STAFF REPORT

Case #21-24: SITE PLAN REVIEW

WS Phillips Road
Map: 136 Lot: 468

Request by applicant for **Site Plan Review** for the construction of a new commercial building and associated site improvements; located on the WS of Phillips Road (Map: 136 Lot: 468) on a 1.9-acre site in an Industrial C (IC) zoned district.

SIDE LEFT ELEVATION - FACING PHILLPS ROAD

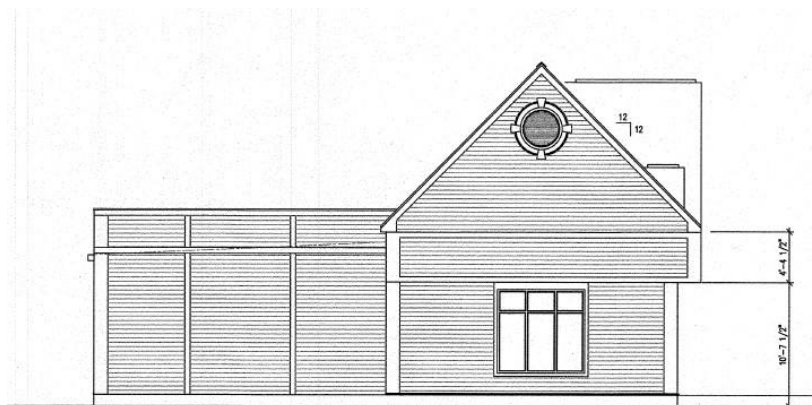
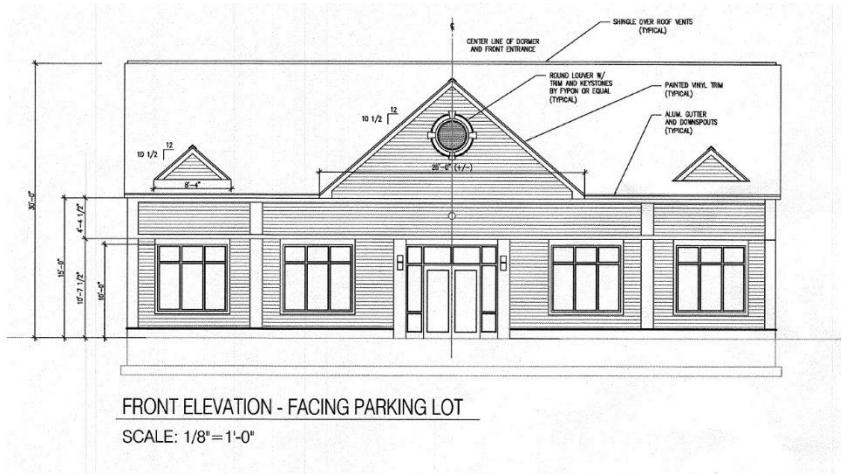
Architectural plans do not indicate the type of material planned for siding on the building. **The Board may wish to inquire as to the siding.**

Architectural plans do not show the south, or rear, elevation. **The Board may wish to request details about the south elevation and condition that the applicant submit revised architectural plans that show the south elevation to the Planning Department for administrative review**

- That the following **specific conditions** be applied to this decision:
 1. The applicant shall submit revised architectural plans that show the south elevations to the Planning Department for administrative review prior to the issuance of a building permit.

There is no sidewalk on the west side of Phillips Road.
Looking north on Phillips Road.

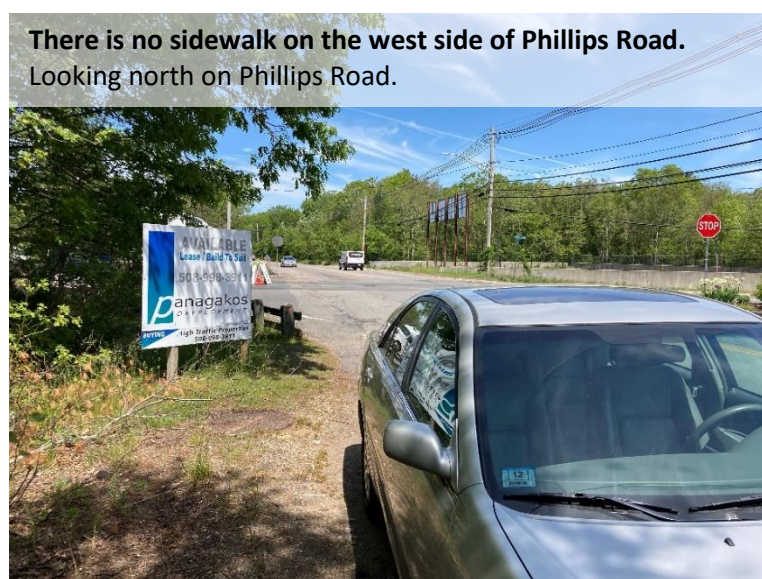
The west side of Phillips Road has no sidewalk, and the applicant does not propose creating one. **The Board may wish to inquire as to how the applicant anticipates pedestrians accessing the site.**
